Re: Docket No. 516 – The United Illuminating Company Application for a Certificate of Environmental Compatibility and Public Need for the Fairfield to Congress Railroad Transmission Line 115-kV Rebuild Project

Enclosed for filing with the Connecticut Siting Council (“Council”) are The United Illuminating Company’s (“UI”) Late Filed Exhibits as requested by the Council during the October 17, 2023 hearing.

Late Filed Exhibit 3-1

Existing Conditions Viewshed Analysis Map with Federal, State, and Local Cultural Resources

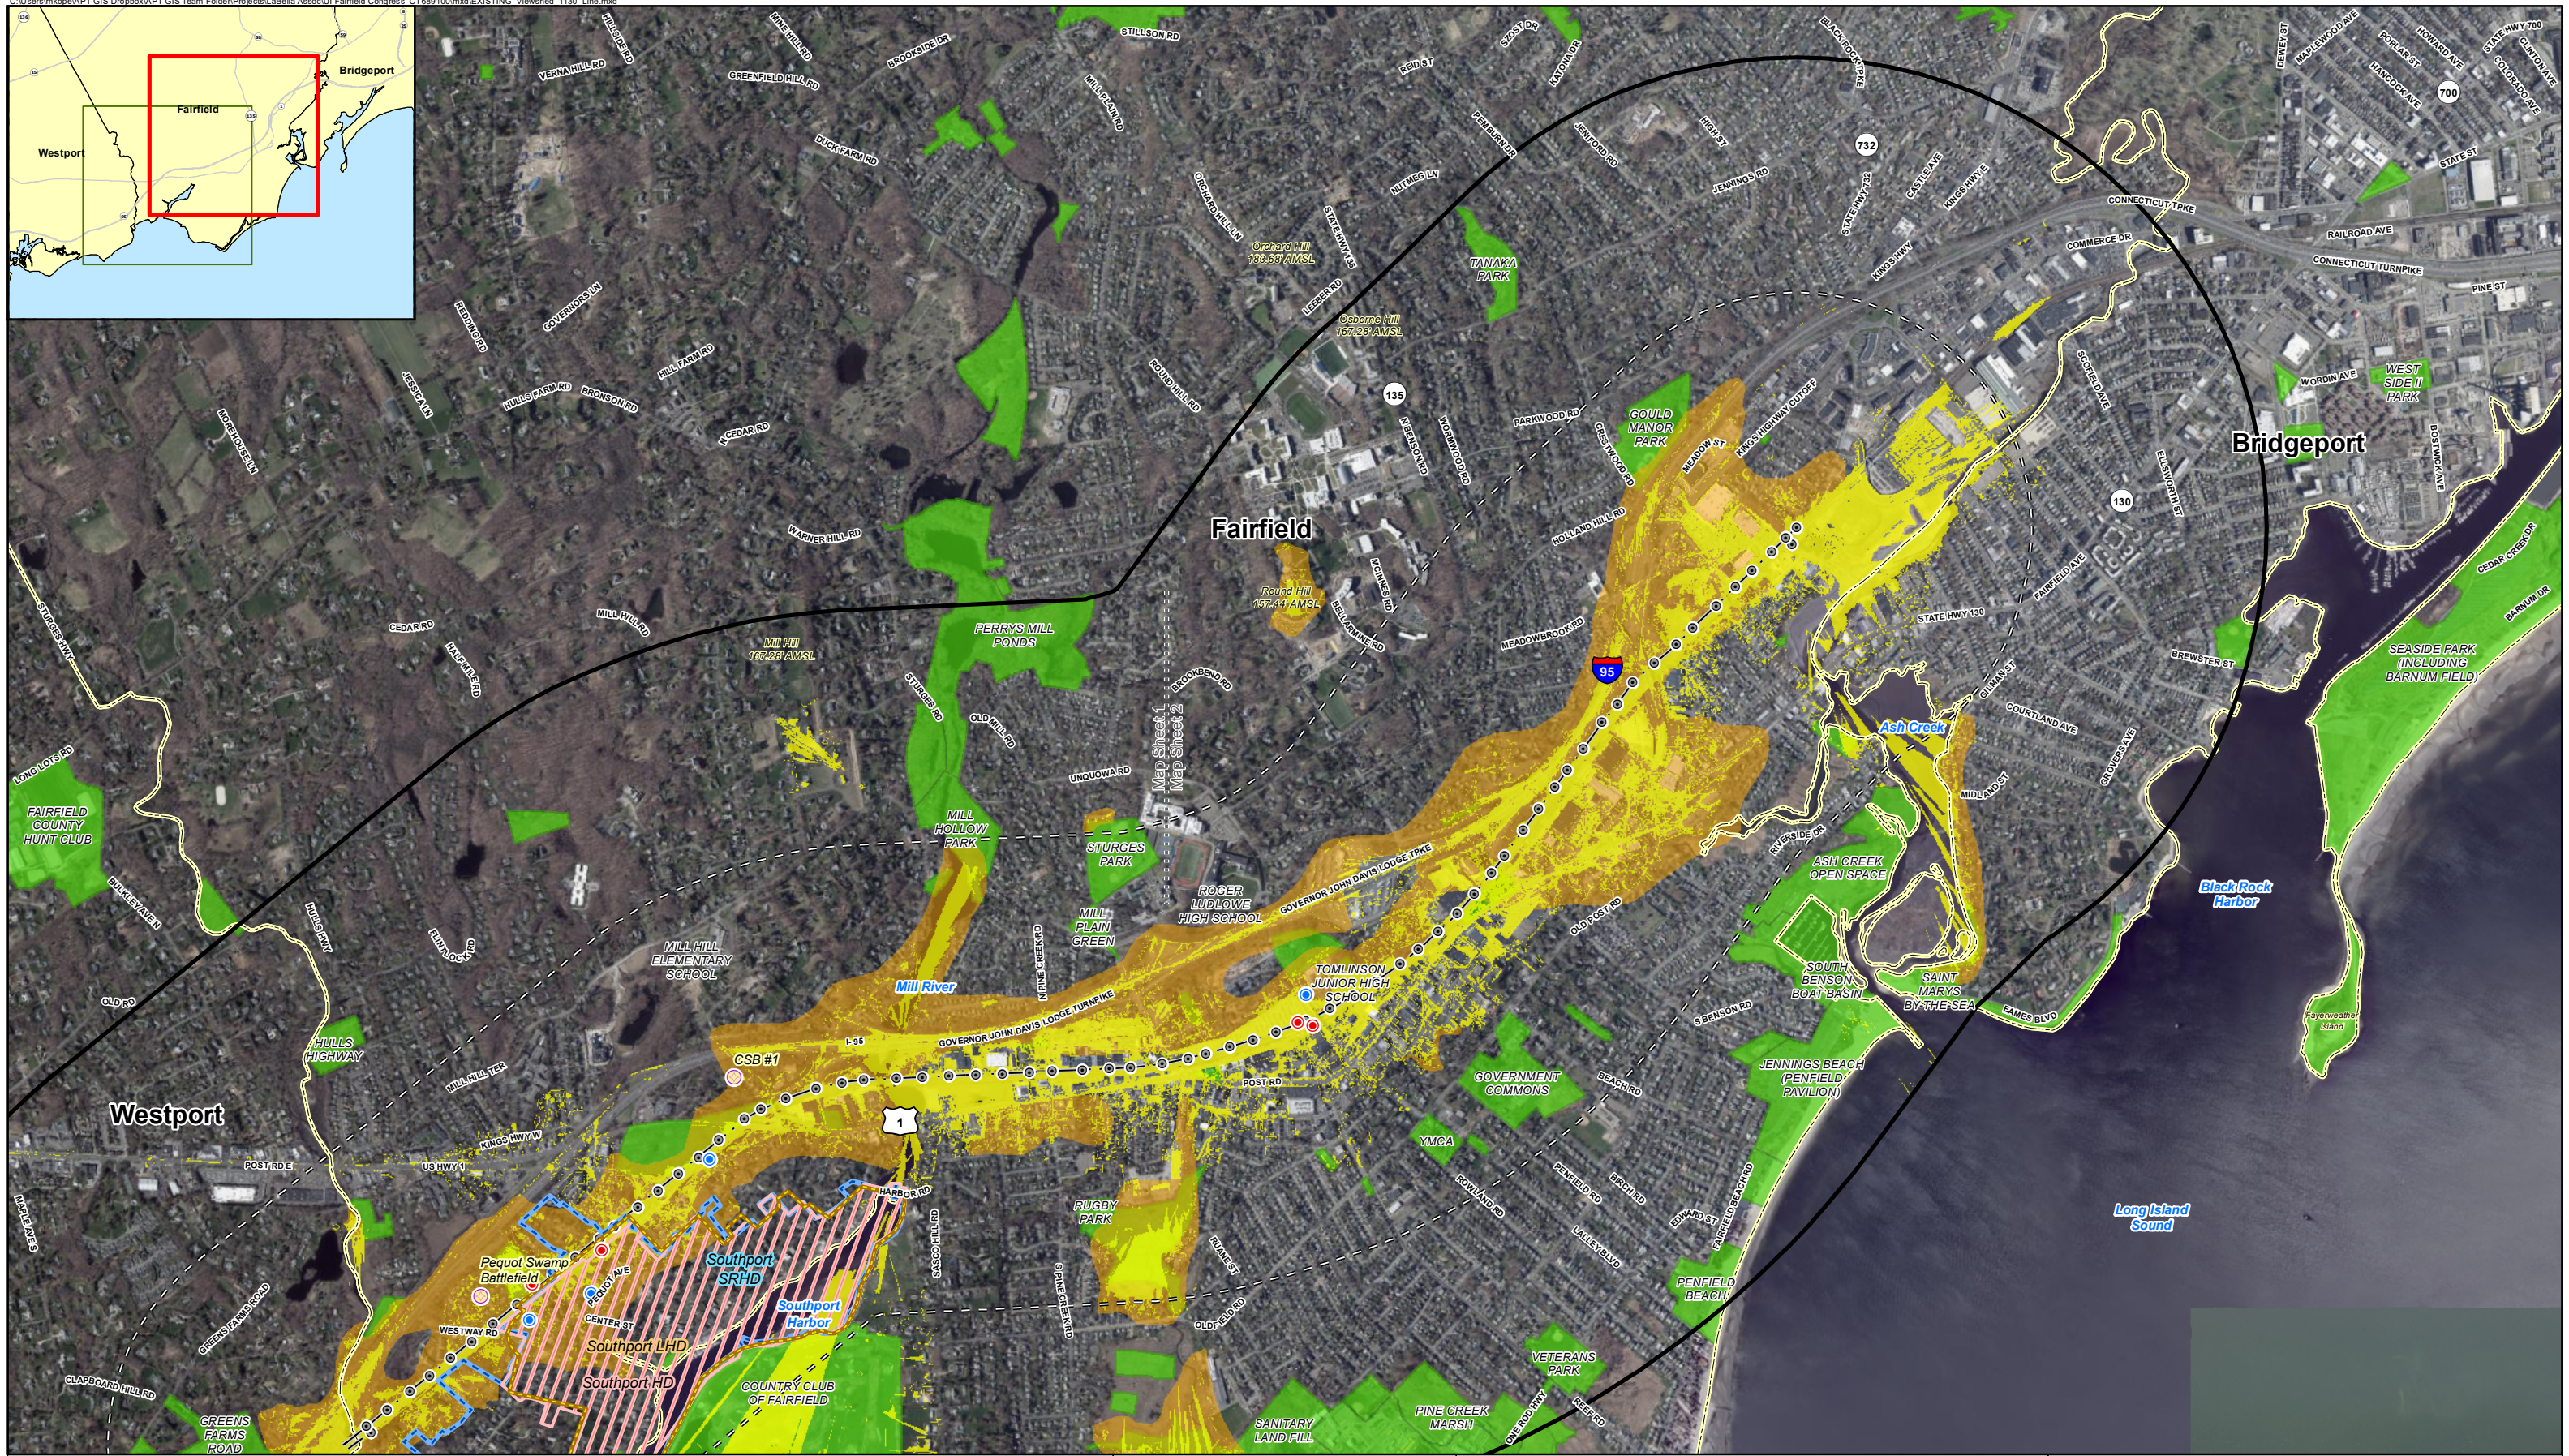
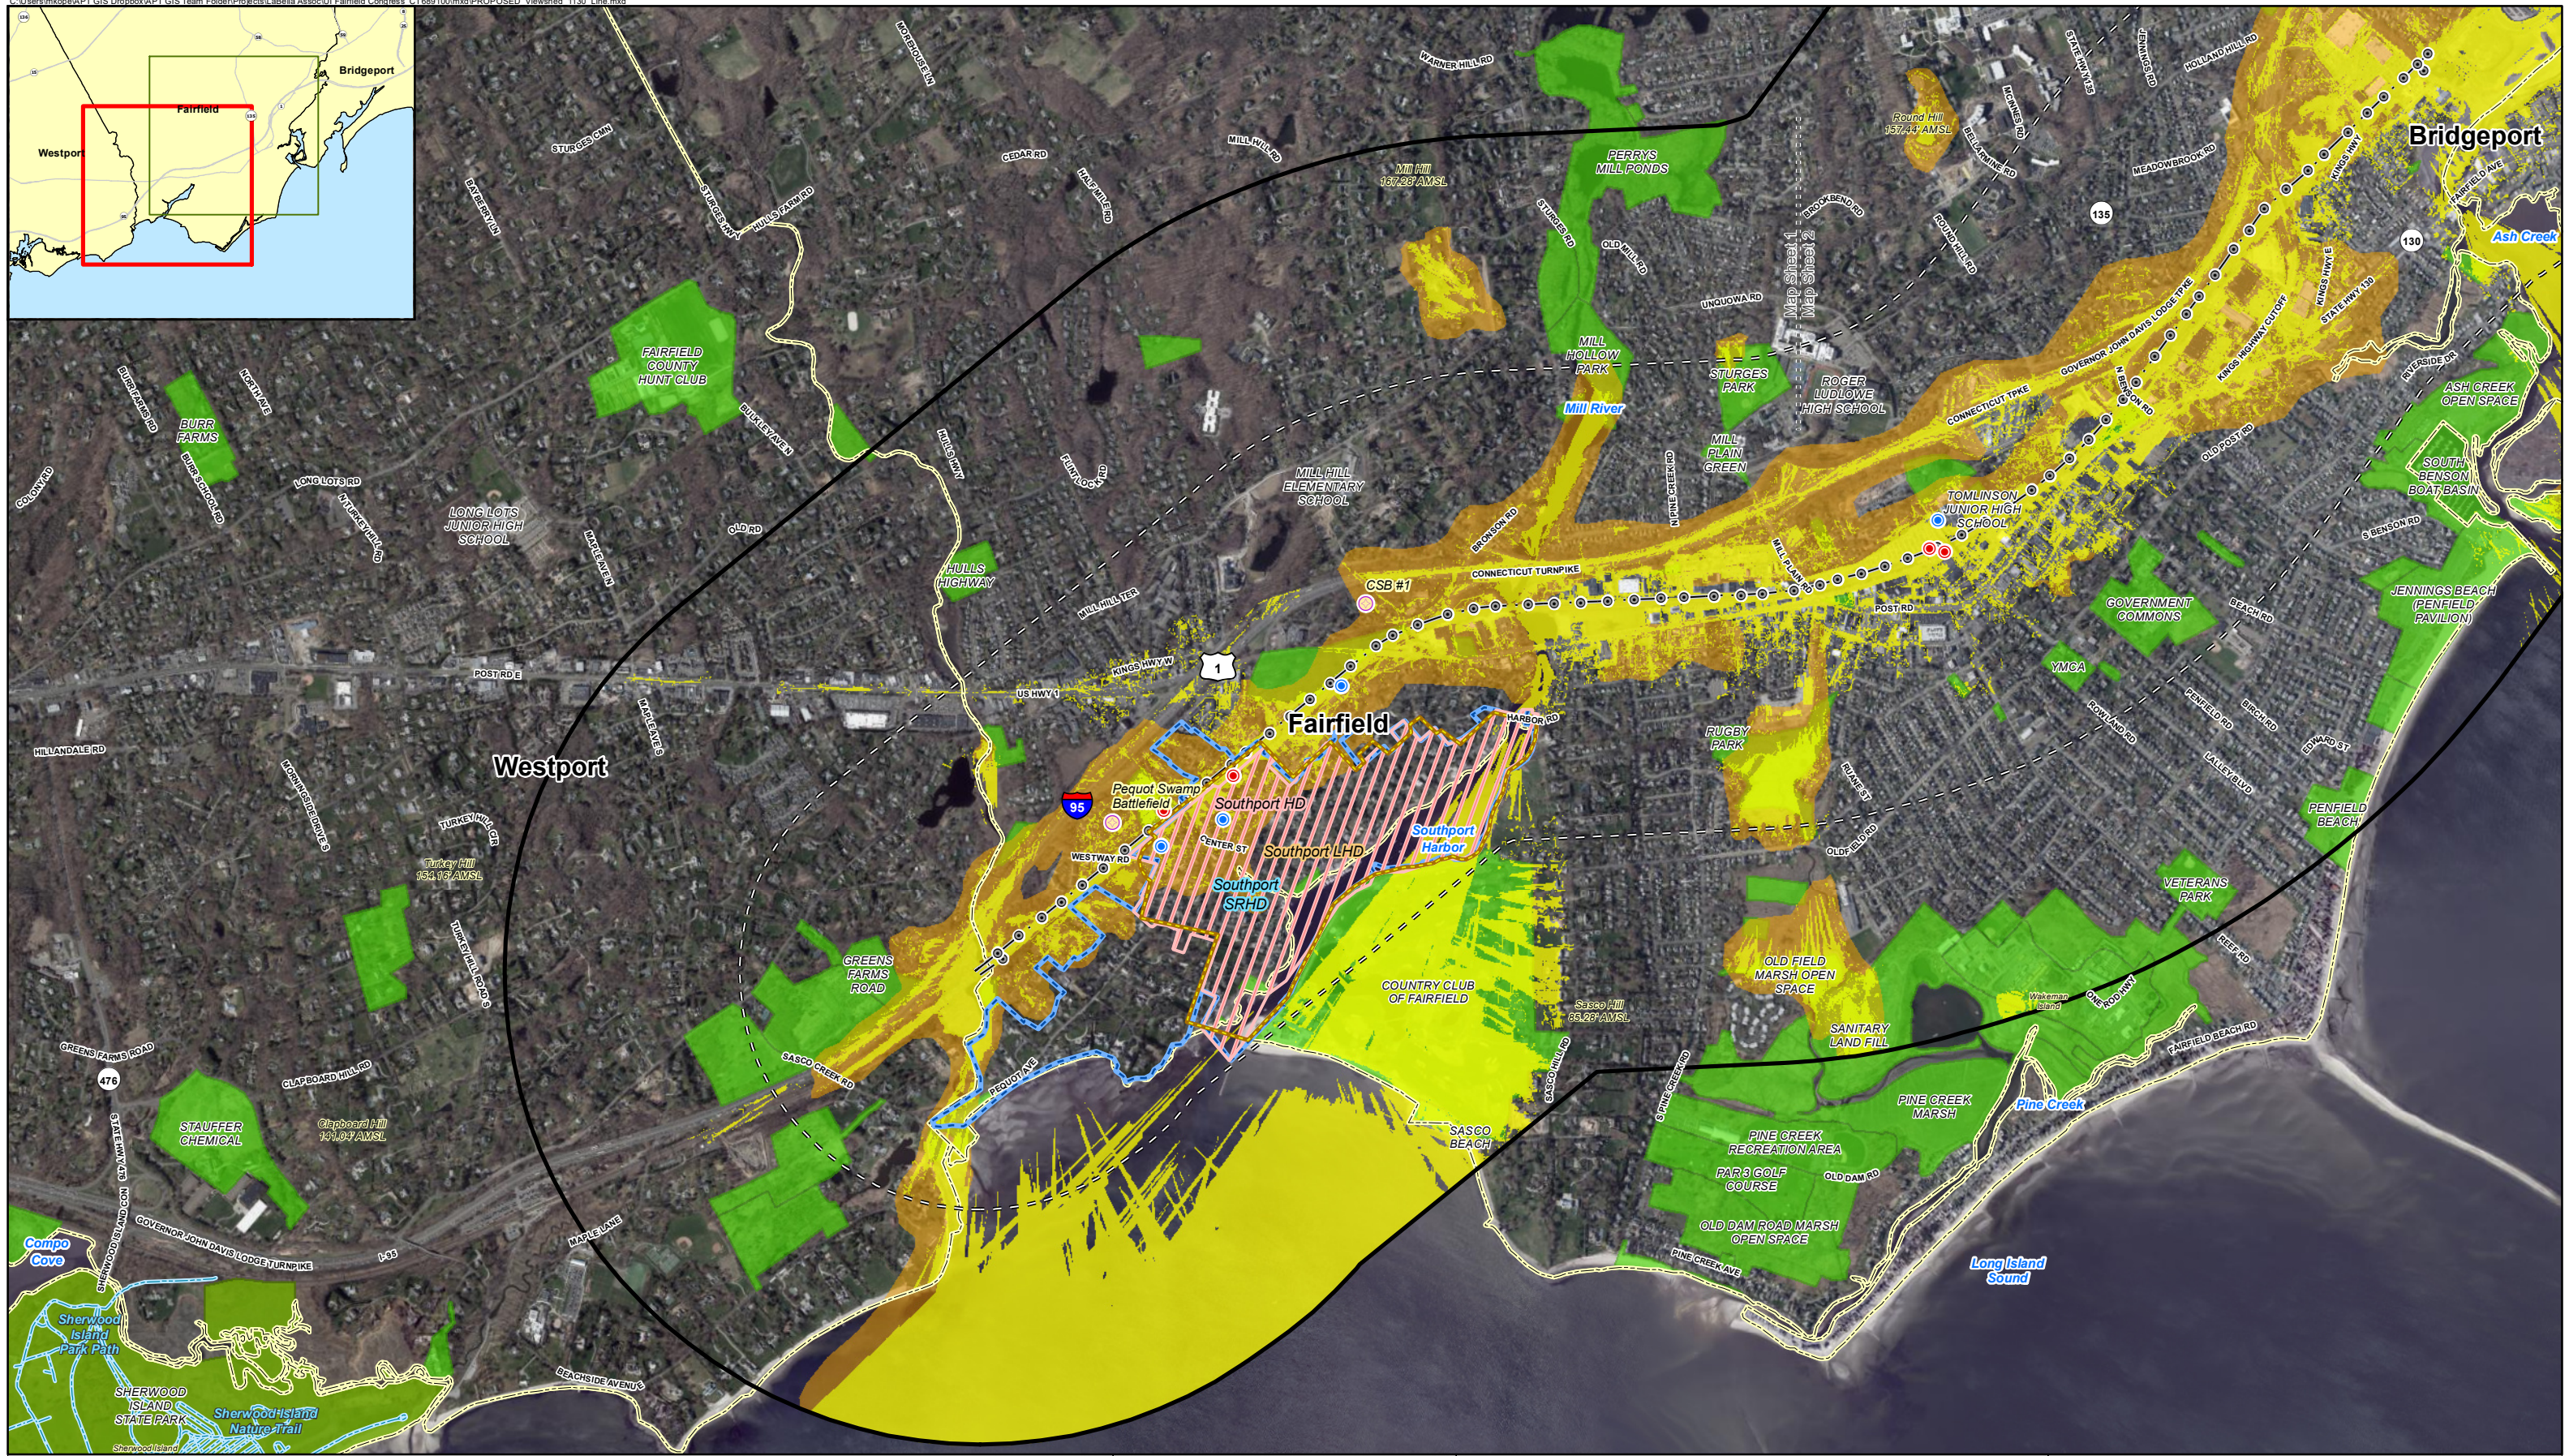
Q-LFE 3-5: Viewshed analysis for the double-circuit monopole configuration alternative from Late File 2-5(a);

A-LFE 3-5: Please see Attachment LFE 3-5-1.
